**Flood Control Project Maintenance
Levee Inspections**

Fall 2019 Levee Maintenance Deficiency Summary Report

Levee Inspection Report By Mile - Fall 2019

Merced Streams Group

Photo 2 of 3 : UCIP_FA_2019_21263_35760.jpg

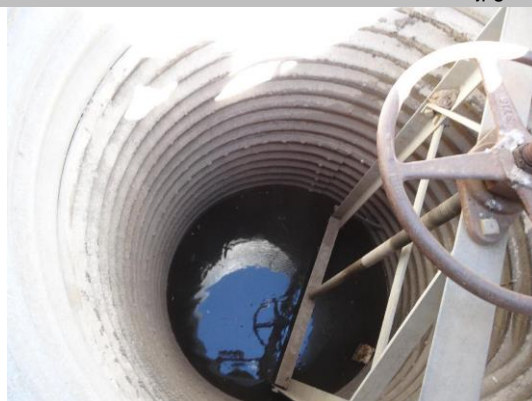
Comment Code						
Inspector Comment						
DS_ID:23052 FS_ID:21263 EP_NO: N/A Repair Type: Non-Urgent Crossing Status: Found UCIP Comments: 09/17/2013 - needs more investigations on this crossing. - new water filtration plant on LS with pump and concrete vault.- a concrete standpipe and CM pipe riser on WS. (DWR UCIP - P. Amatya) FIELD_STRUCT_DESC: 10-inch steel irrigation pipe through the levee, 5 feet below the crown. Riser on the landside (LS). Screw gate in a 36-inch pipe well on the waterside (WS) slope. [Additional Reference(s): DWR Levee Log, 2005. USACE San Joaquin O&M Manual 607, June 1962, (HLM 0.00)]. FS Date: 9/17/2013

WS view: inside view of CMP standpipe with slide gate.

Photo 1 of 3 : UCIP_FA_2019_50149_35535.jpg

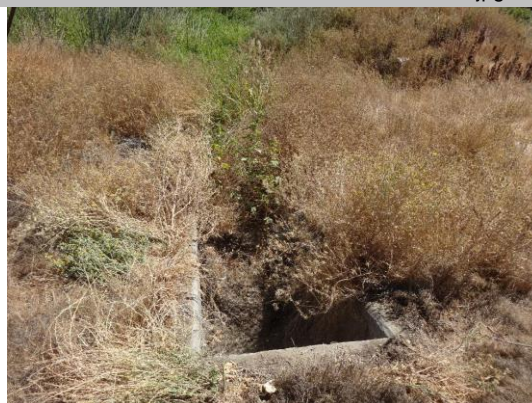
Comment Code					
Inspector Comment					
DS_ID:23062 FS_ID:50149 EP_NO: N/A Repair Type: No Action Needed Crossing Status: Found UCIP Comments: 09/29/2016: LS and WS ends have been cleared by Mike Walejko of NA0013. Crossing has been downgraded from Non-Urgent to No Action Needed. (K. Fazel - UCIP)09/2013:- needs clearing and cleaning on inlet and outlet. (P. Amatya - UCIP) FIELD_STRUCT_DESC: 24-inch corrugated metal gravity drainage pipe through the levee, 7.5 feet below the crown. Concrete headwall, flap gate, and concrete grouted cobble spillway on the waterside (WS) toe. Concrete headwall on the landside (LS) toe. [Additional Reference(s): DWR Levee Log, 2005. USACE San Joaquin O&M Manual 607, June 1962, (HLM 0.59), referenced as 10 feet below the crown]. FS Date: 9/7/2016

WS view: cobble spillway and channel on waterside. Dense vegetation on levee slope.

Photo 2 of 3 : UCIP_FA_2019_21064_35505.jpg

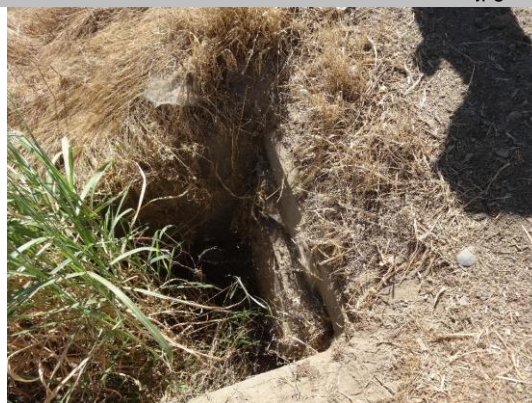
Comment Code						
Inspector Comment						
DS_ID:23066						
FS_ID:21064						
EP_NO: N/A						
Repair Type: Non-Urgent						
Crossing Status: Found						
UCIP Comments: 09/17/2013 - needs clearing and cleaning of						
vegetations on both ends of the pipe.- needs clearing and cleaning of						
silt deposited inside of the pipe. (DWR UCIP - P. Amatya)						
FIELD_STRUCT_DESC: 24-inch corrugated metal gravity drainage pipe						
through the levee, 4 feet below the crown. Concrete headwall, flap gate,						
and concrete grouted cobble spillway on the waterside (WS) toe.						
Concrete headwall on the landside (LS) toe. [Additional Reference(s):						
DWR Levee Log, 2005. USACE San Joaquin O&M Manual 607, June						
1962, (HLM 1.29)].						
FS Date: 9/17/2013

WS view: U typed concrete headwall, CM pipe, and flap gate. Vegetation needs to be cleared.
